TC_TH

Description Redesign

RFID_UNI

2810b

2.2.1 General Changes to existing design

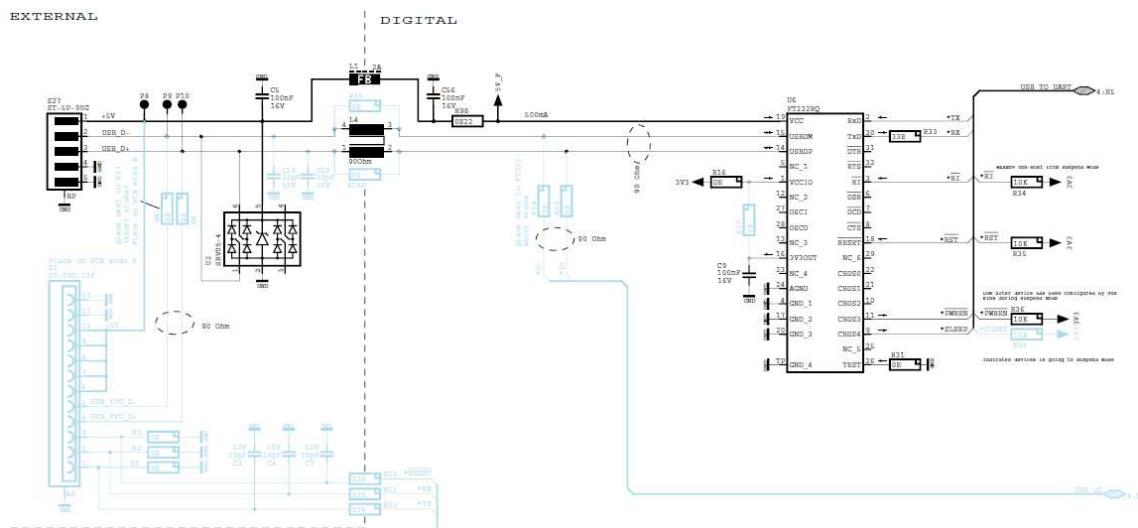
The following changes have been made to internal job number 2810a → 2810b in the schematic in all versions.

- Connector S1 (12-P) removed; only one more connection option (S27 / 5-P)
- IC-U25 ISL83072 (RS485 transceiver) added
- Control line (EN) between U4 (LPC11E6x) and RFID-Chip U5 (TRF7970A) was pin swapped at U4 from pin #30 to pin #25. The reason for this pin swap is that the previously existing EN output of the LPC11E6x is required for RS485 driver switching.

2.2.2.1 Old version 2810a (is replaced)

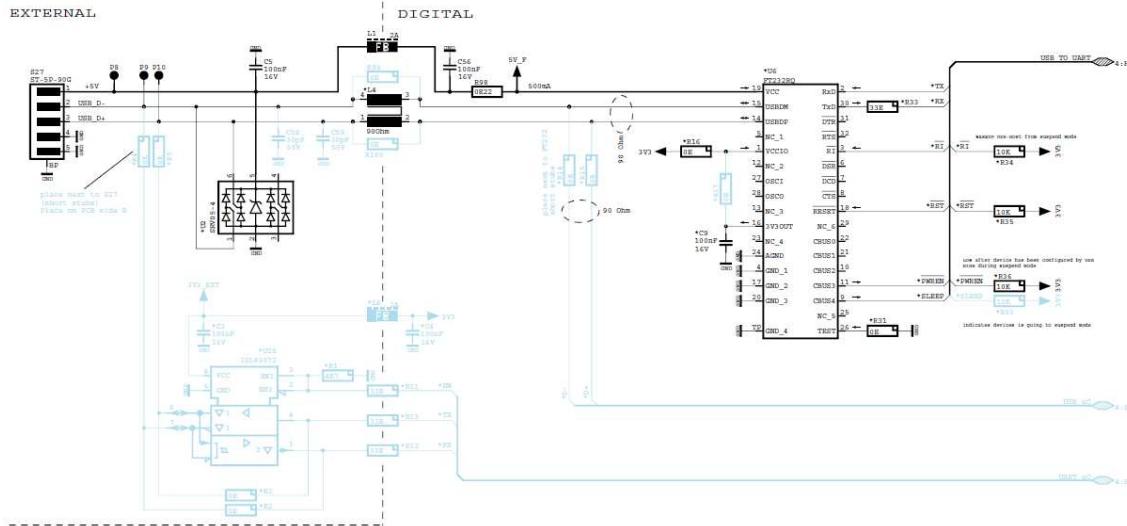
Two connectors for internal communication, no RS485 transceiver available.

2.2.2.2 V1_USB_UART_5MM or V2_USB_UART

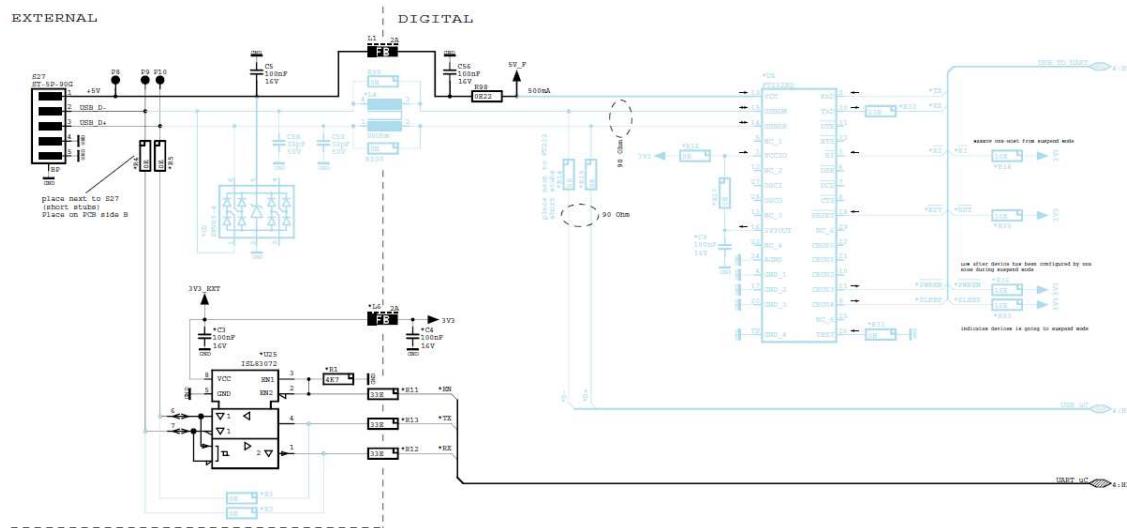
Internal communication via USB (existing design; internal job number 2810a → 2810b)
 V1: 5mm spacer soldered
 V2: ident to V1, but 8mm spacer soldered

2.2.2.3 V3_RS485

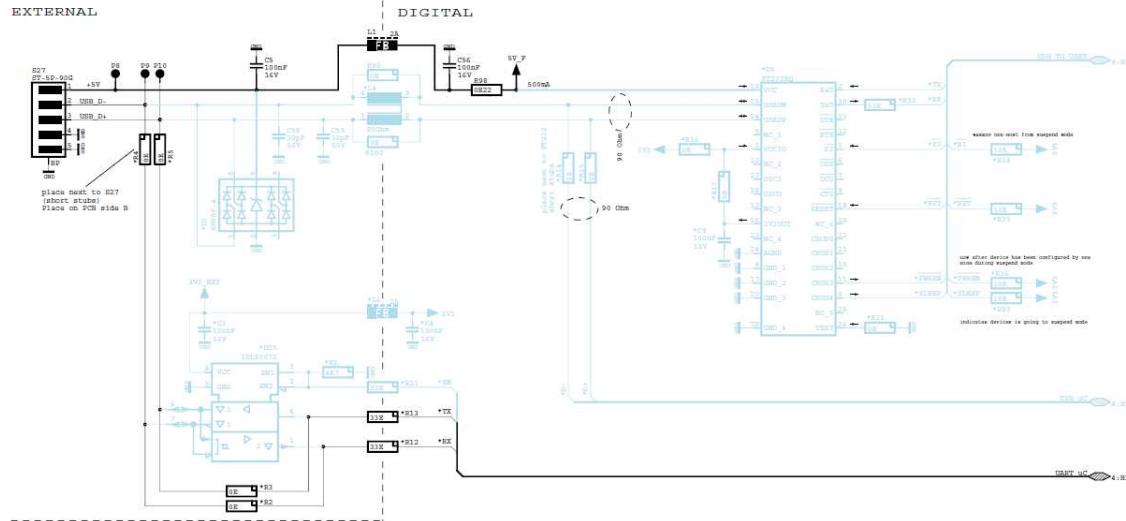
Internal communication via RS485 (NEW; internal job number 2810b)

2.3 Changes in Layout Design

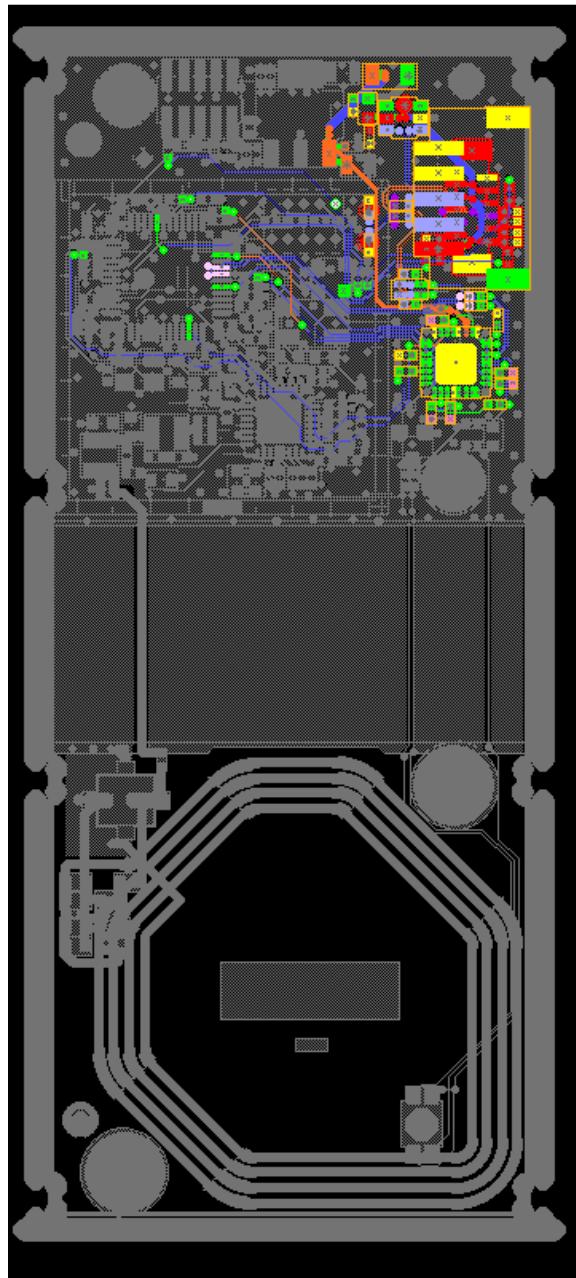
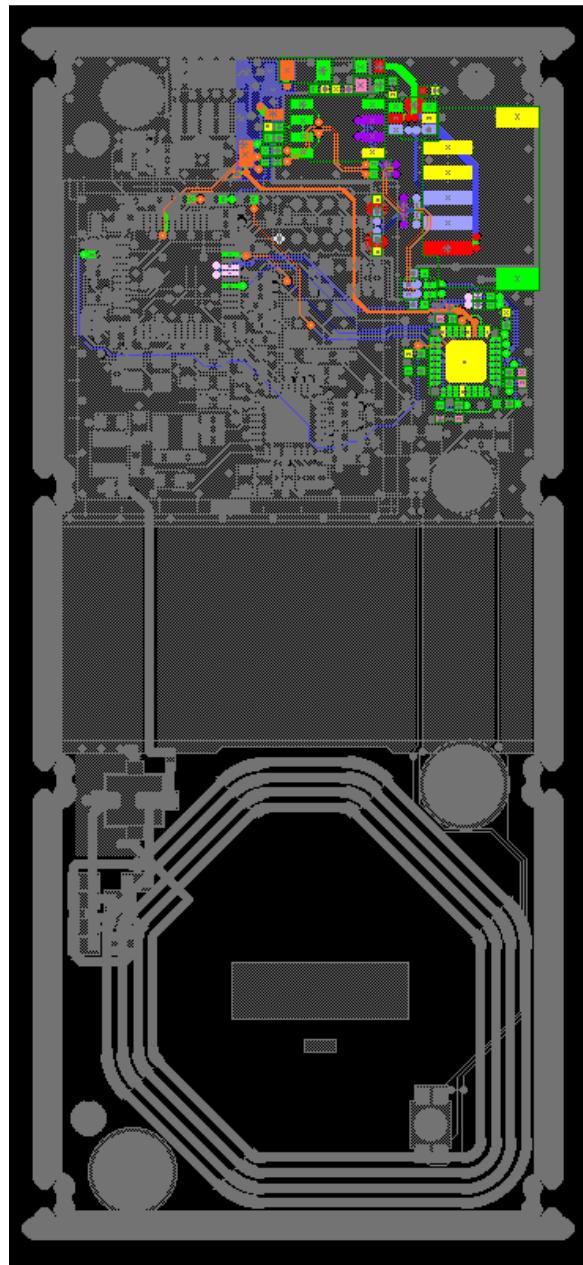
The following changes were made due to the adaption of the communication interfaces on the existing design.
